33.2.3.5 State diagrams

Figure 33-5—PSE state diagram

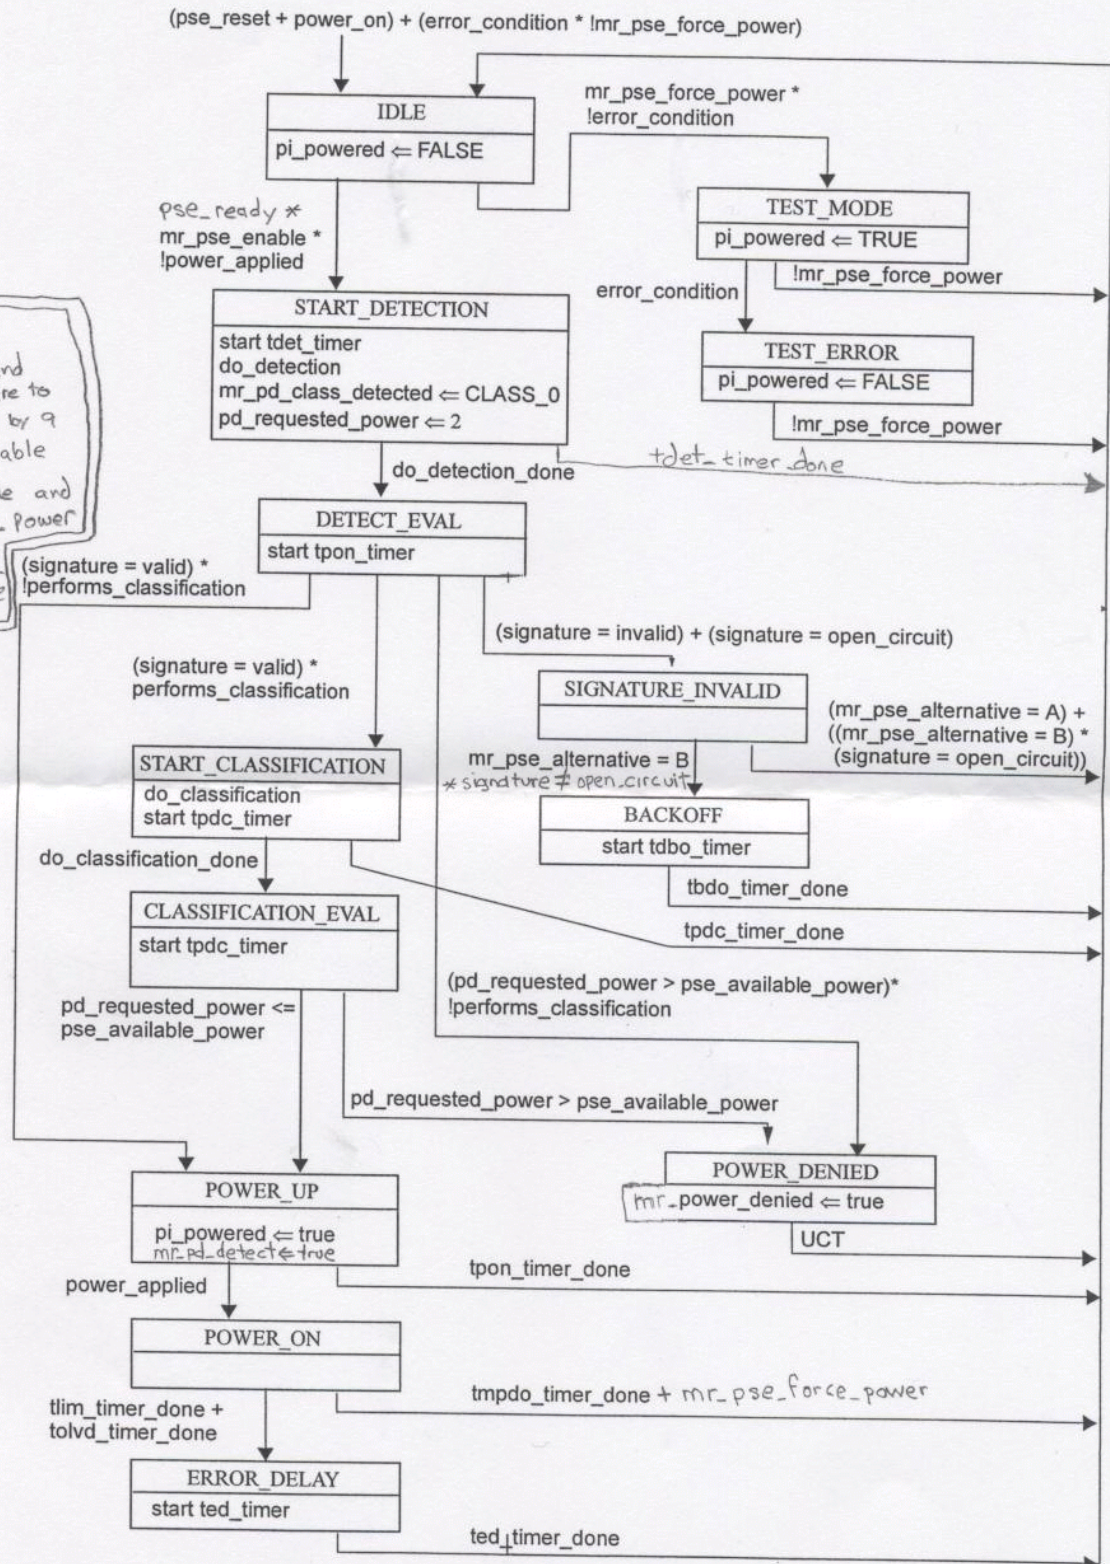
Note:
1) pse_reset and power_on are to be replaced by a single variable
2) mr_pse_enable and mr_pse_force_power are to be a single enumerated variable
